Appendix R

RESPONSES TO PUBLIC COMMENTS

Introduction to the Responses to Comments on the One Paseo Environmental Impact Report

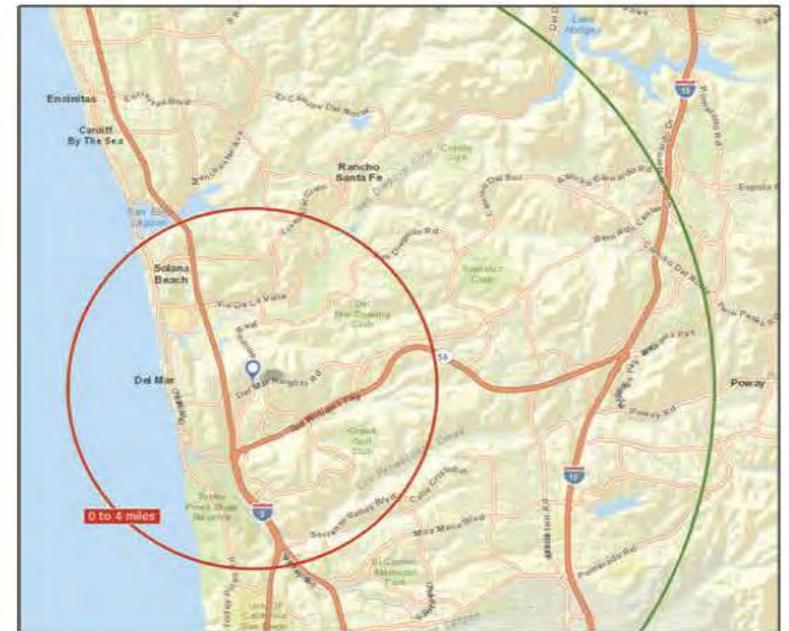
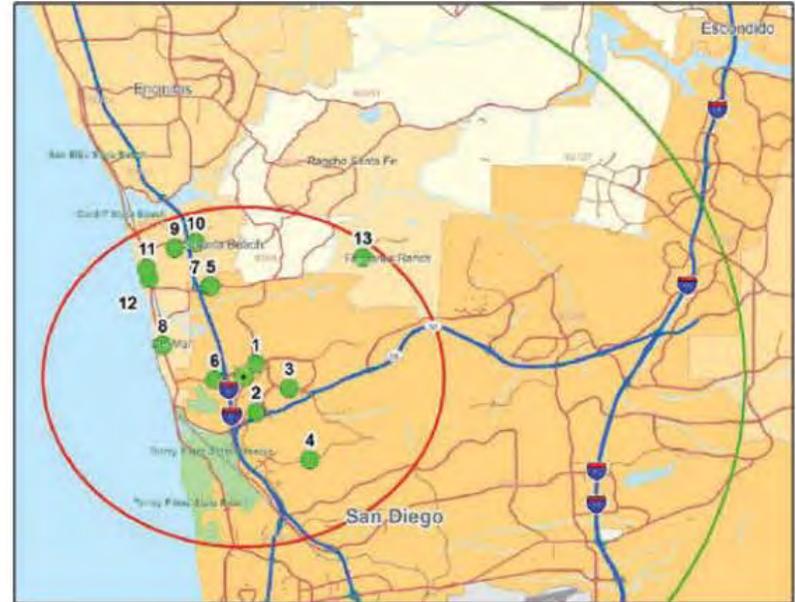
- 10.73 As indicated in the comment, some recently constructed streets do not appear in Figures 3-5 on pages 7-9 of the RMA in Appendix B of the Draft EIR (see extracted image/area from Figure 3 of the RMA below). The recently constructed roads are shown in the additional map below, generally within the area denoted within the yellow circle. As the precise configuration of the roadway network does not affect the retail market analyses, the addition of the roads has no impact on the analysis or conclusions of the RMA.

Long-term Cumulative (Year 2030)
With Project ADT Volumes
ONE PASEO
Figure 5.2-8

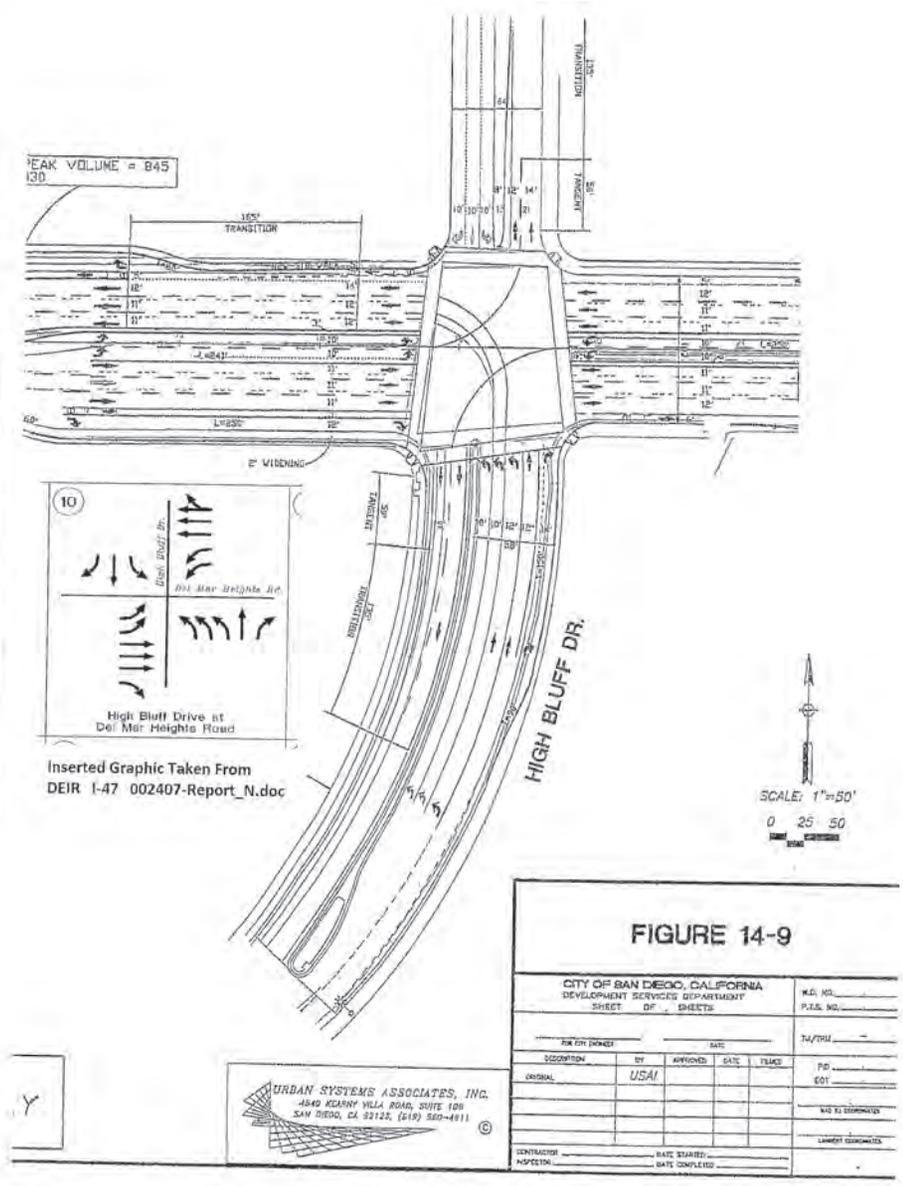
The DEIR shows the Long-term Cumulative (Year 2030) With Project ADT Volumes for **proposed** One Paseo. (DEIR Figure 5.2-8) There are no Project ADT Volumes indicated for High Bluff Drive in Neighborhood Three. **Why is there no analysis reported in the DEIR when clearly Neighborhood Three will have impacts? What are the Long-term Cumulative (Year 2030) With Project ADT Volumes for the following?**
High Bluff Drive - between Del Mar Heights Road and Long Run Drive
High Bluff Drive - between Long Run Drive and Half Mile Drive
Long Run Drive - between High Bluff Drive and Quarter Mile Drive
Wyndhaven Drive - Between Quarter Mile Drive and Half Mile Drive
